Addendum 36 – Regulation No. 37

Revision 7 - Amendment 5

Supplement 42 to the 03 series of amendments – Date of entry into force: 10 June 2014

Uniform provisions concerning the approval of filament lamps for use in approved lamp units of power-driven vehicles and of their trailers

Sheet WT21W/1

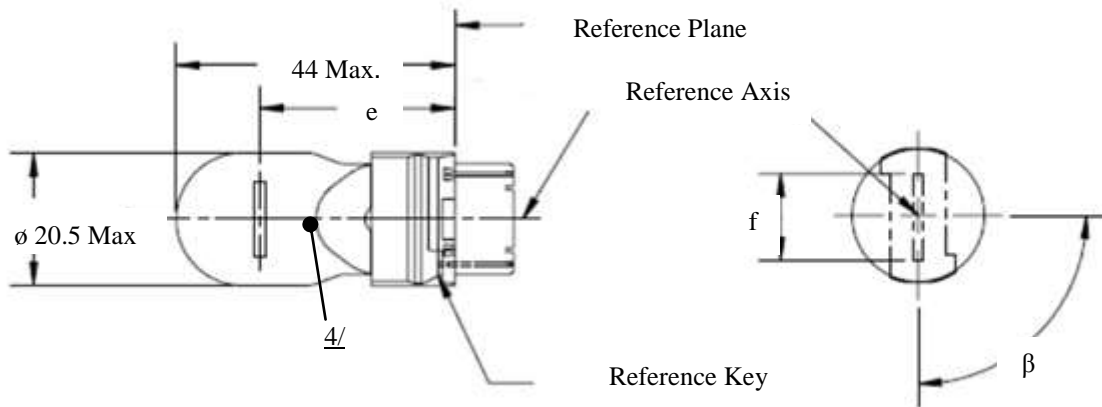
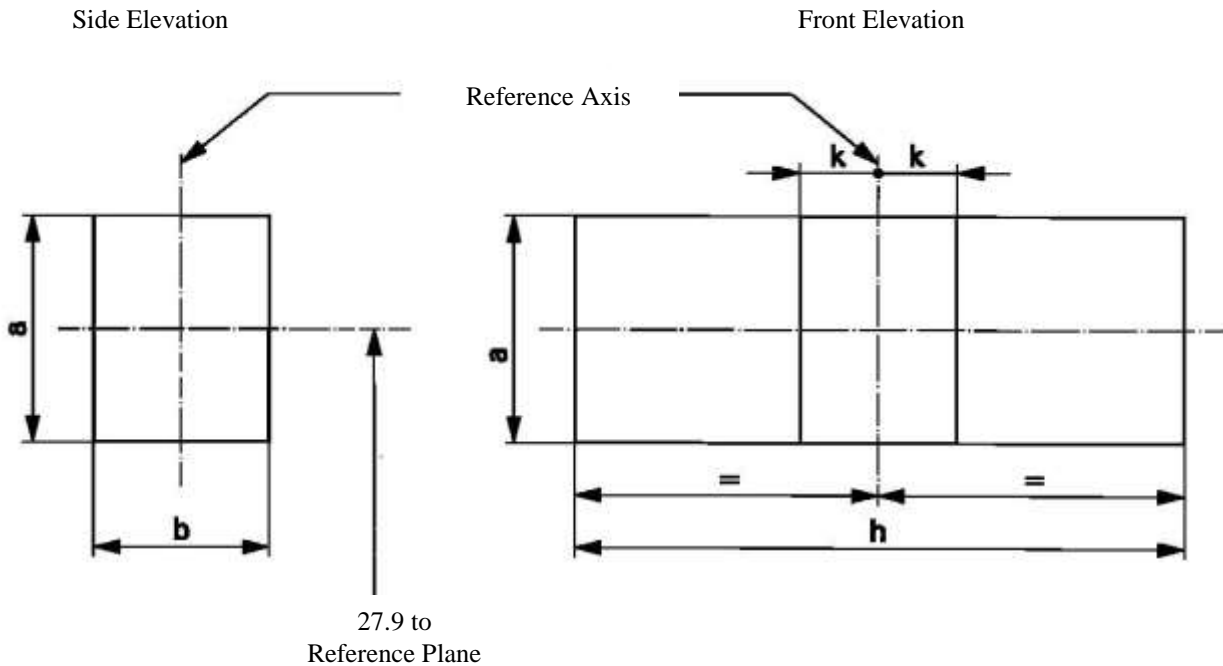
Insert new sheets WT21W/1 to 2 and WT21/7W/1 to 3 between sheet WR21/5W/1 and sheet WY2.3W/1, to read: (see next pages):

Dimensions in mm		Filament lamps of normal production			Standard filament lamp 5/
		min.	nom.	max.	
e	12V		27.9 ^{3/}		27.9 ± 0.3
	24V	26.9	27.9	28.9	
f				7.5	7.5 + 0 / - 2
Lateral deviation ^{2/}	12V			^{3/}	0.0 ± 0.4
	24V			1.5	
β		75° ^{3/}	90°	105° ^{3/}	90° ± 5°
Cap: WT21W: WUX2.5x16d WTY21W: WUY2.5x16d		in accordance with IEC Publication 60061			(sheet 7004-[...]-1) (sheet 7004-[...]-1)
Electrical and photometric characteristics					
Rated values	Volts	12	24	12	
	Watts	21			21
Test voltage	Volts	13.5	28.0	13.5	
Objective values	Watts	26.5 max.	29.7 max.	26.5 max.	
	Luminous flux	WT21W	460 ± 15 %		
		WTY21W	280 ± 20 %		
Reference luminous flux at approximately 13.5 V:					White: 460 lm Amber: 280 lm

^{3/} To be checked by means of a "Box-System", sheets WT21W/2.

^{4/} The light emitted from filament lamps of normal production shall be white for category WT21W and amber for category WTY21W (see also note 5).

^{5/} The light emitted from standard filament lamps shall be white for category WT21W and white or amber for category WTY21W.

Example of the arrangement of the approval mark

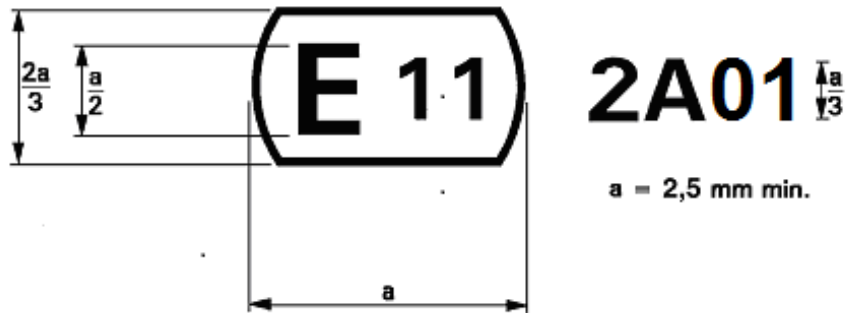
Annex 3, amend to read:

The above approval mark affixed to a filament lamp indicates that the lamp has been approved in the United Kingdom (E 11) under the approval code A01.

The first character of the approval code indicates that the approval was granted in accordance with the requirements of Regulation No 37 as amended by the 02 and 03 (*) series of amendments."
